## LATE OBSERVATIONS FOR PANEL BASED ON PLANNING OFFICER REPORT

Application 21/01721/FULL: Sunningdale Park Larch Avenue Ascot SL5 OQE

## Application 21/01721/FULL: Sunningdale Park Larch Avenue Ascot SL5 0QE

Steuart and Crosley- approved scheme- street view from Larch Avenue

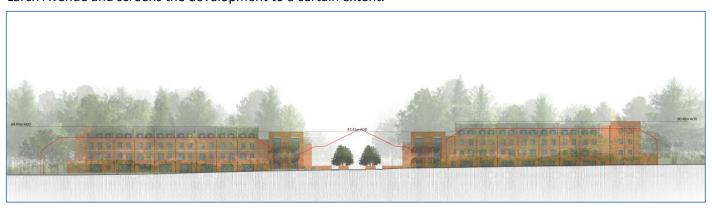
The street scene for the approved scheme for Crosley and Steuart (shown below), although described as 'repetitive and symmetrical' in the Design and Access Statement, does blend in as a single ridge height behind the trees along Larch Avenue and screens the development to a certain extent.

However, in the proposed scheme, the developer has now introduced large sections at the corners which are significantly higher than the approved scheme. This increases the overall bulk of the building.

Approved Scheme (2019

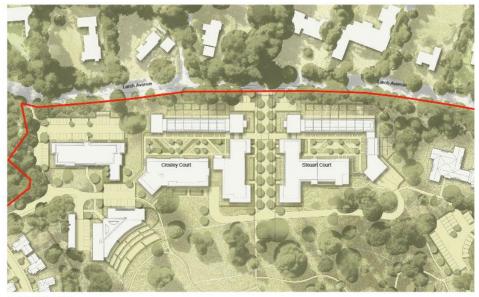
This application proposes architectural changes to Crosley and Steuart Court which are significantly different to the architectural style of the approved scheme. The three pictures below show the architecture of the approved scheme with respect to these blocks.

The developers have used a Collegiate theme as their new architectural link to distance themselves from the previously approved design. Now there are references to *Scholars Row, Crosley Classrooms* and *The Great Hall* in the Design and Access statements to reflect this new scholarly theme.

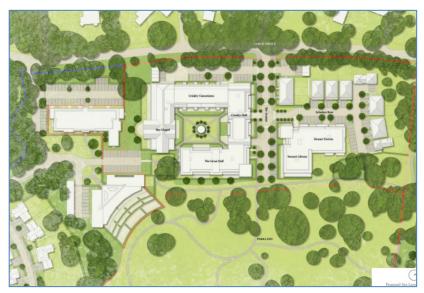
The sheer scale, bulk and height of the proposed changes can be seen in the illustrations below. These also now include the introduction of a wide variety of architectural features.

The layout out and positioning of these build elements has also changed as shown below. Continuing the urban theme, the positioning of the Crosley buildings in a square is more concentrated with less open views than on the approved scheme.

The Southern flank of The Crosley Great Hall also appears to be dangerously close to a TPO tree as can be seen in the diagram below. It is difficult to see how the RPA of this tree will not be compromised. It is noted that no additional tree works are envisaged with this latest proposal.
